# UNITED STATES PATENT AND TRADEMARK OFFICE

10/656,409

## Office Action Summary

## DETAILED ACTION

FIG. 1a

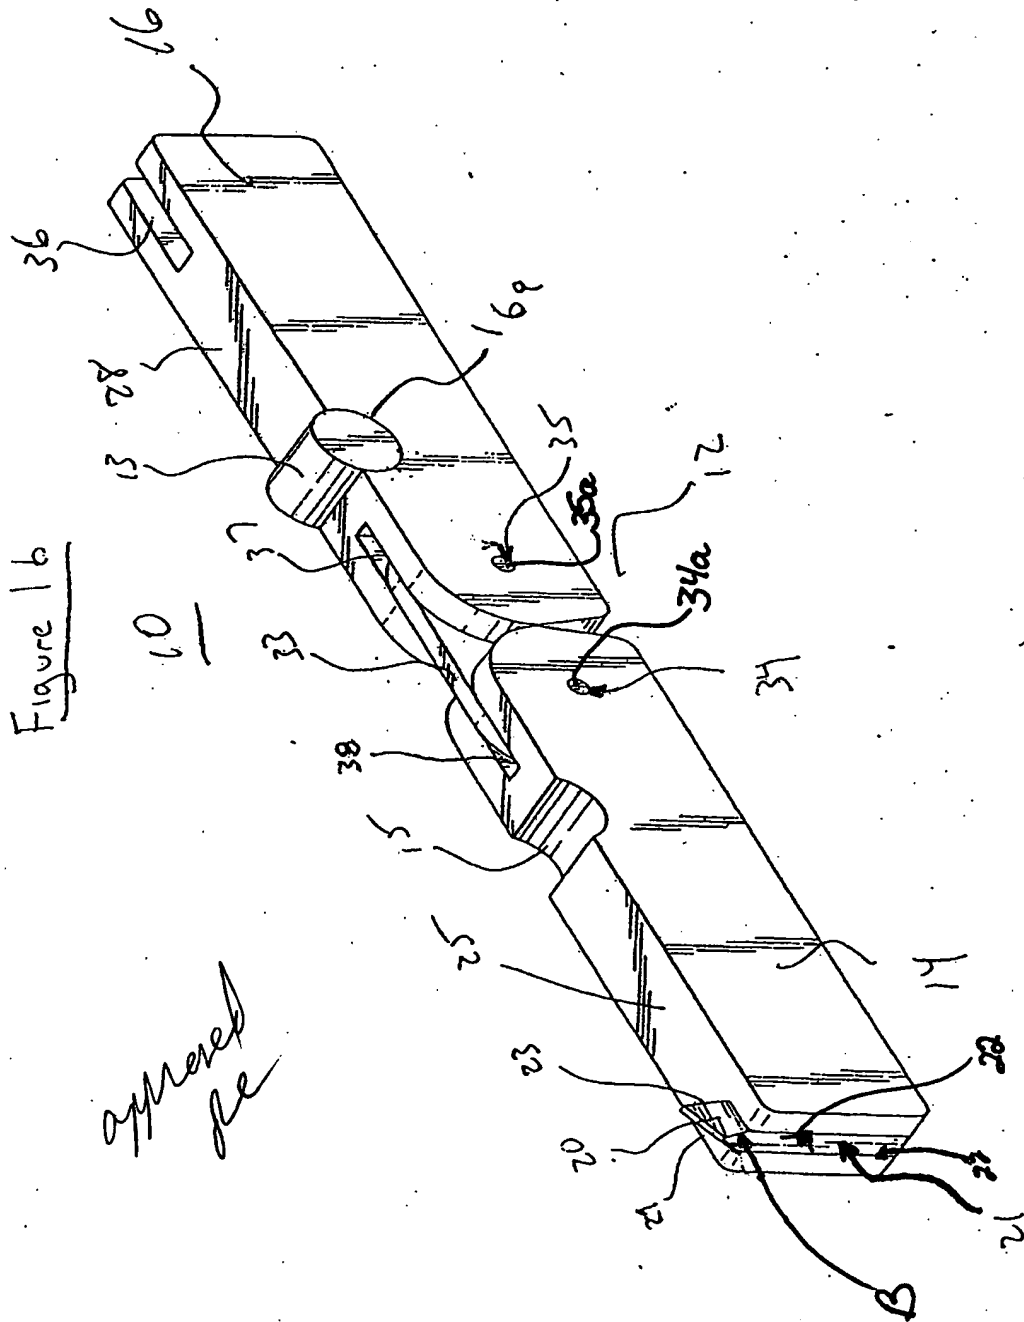
Furthermore, the first inner side and second inner side could even be considered **planar**, to an extent viewing Figs. 1b or 3. Accordingly, there is no exact measure as to what constitutes "planar" and "non-planar". In any case, such phrases constitute new matter and are even indefinite and inaccurate since the scope of the claims cannot clearly and accurately be ascertained.

As for claim 16, viewing Fig. 1b, it does not appear that the blade is tapered from a distal point "**proximally**" to the connection point (emphasis added) rendering confusion.
